**E8364B-03**

# **S E R V I C E N O T E**

## **E8364B PNA Microwave Network Analyzers**

**Figure 1:** A3 Front Panel Interface Board Assy without the Bracket

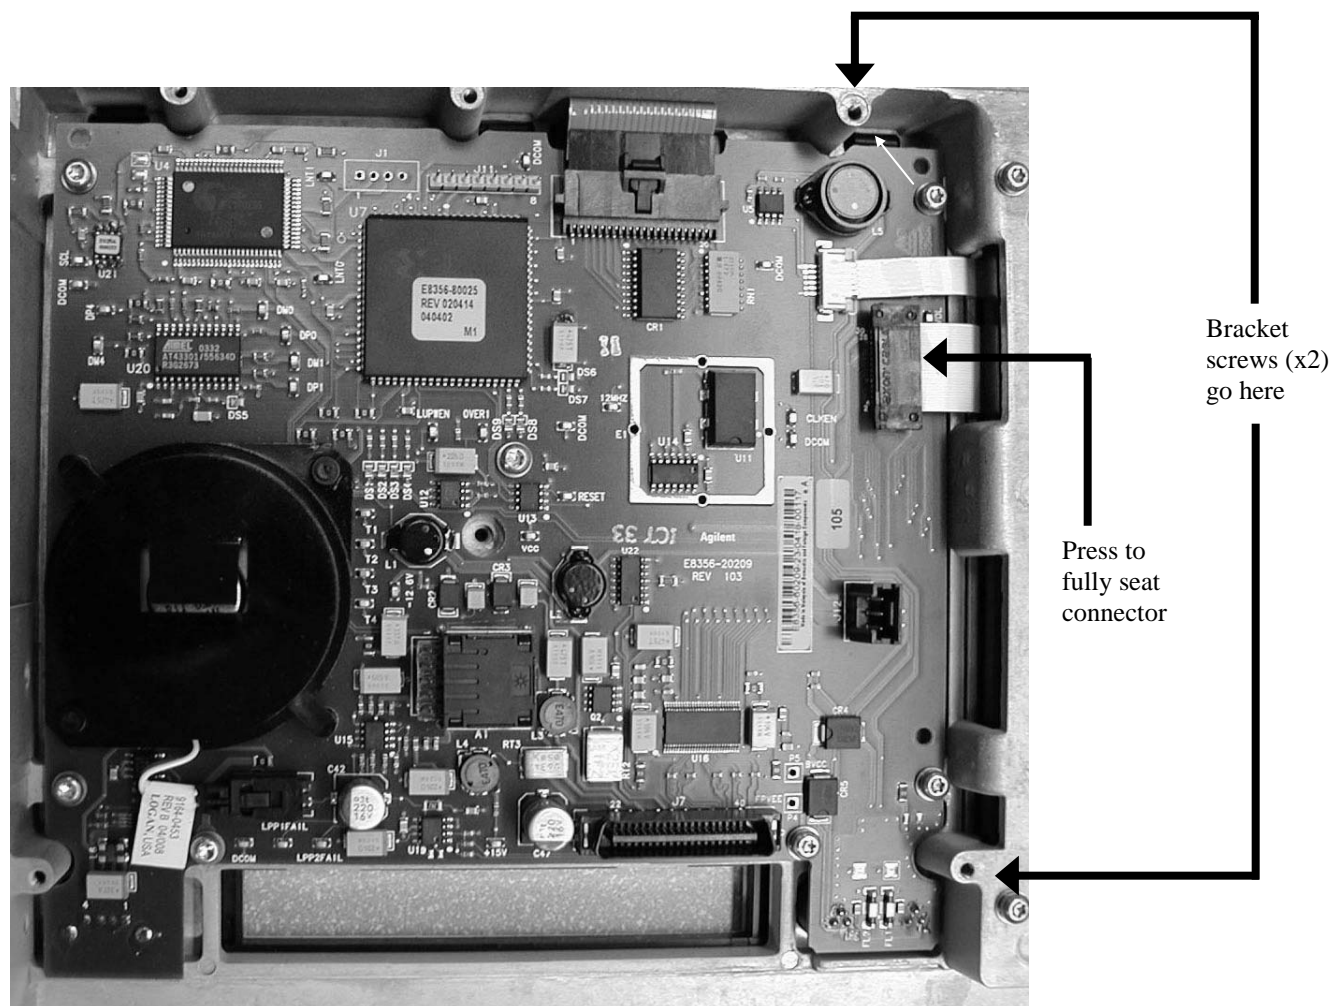
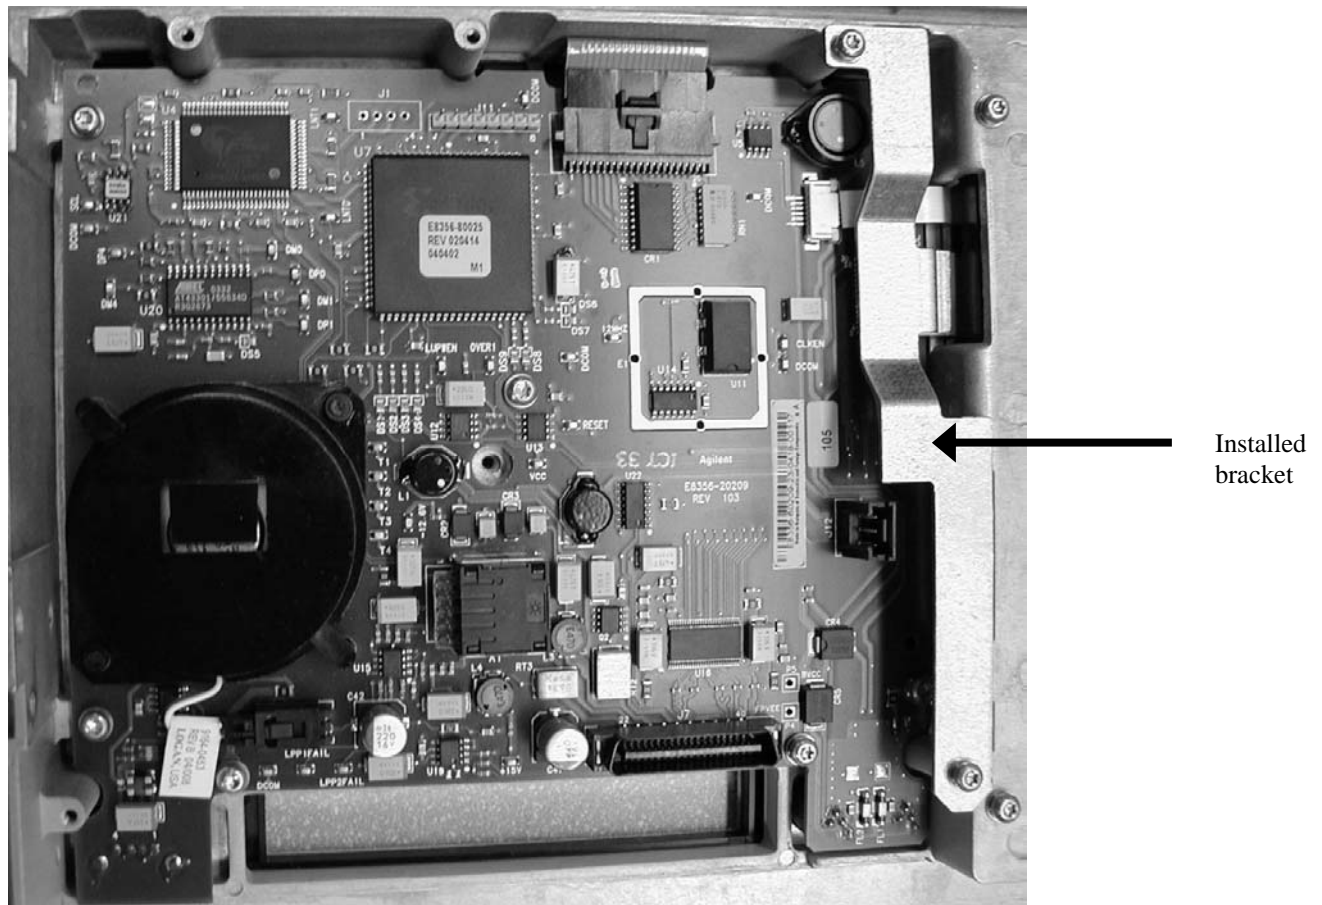
A connector of the ribbon cable (Agilent part number 8120-8409) that joins the front panel display to the front panel interface board can loosen, causing a display failure, unless a new bracket is installed. Because the failure rate has been very low, it is recommended that the bracket be installed only when there is an additional reason to remove the PNA front panel.

1. Refer to Figure 1 in this document:
  - Press down firmly on the ribbon cable's black connector.
  - Locate the two tapped holes for the bracket screws.
2. As shown in Figure 2 in this document, position the bracket so that its holes line-up with the two holes you located in the previous step.
3. Hand-start the two screws, and then torque both to 9 in-lbs.
4. Reinstall the PNA Front Panel by following the Service Guide instructions in the "Replacement Procedure." This is located on the same page as the "Removal Procedure" used previously in step 7.
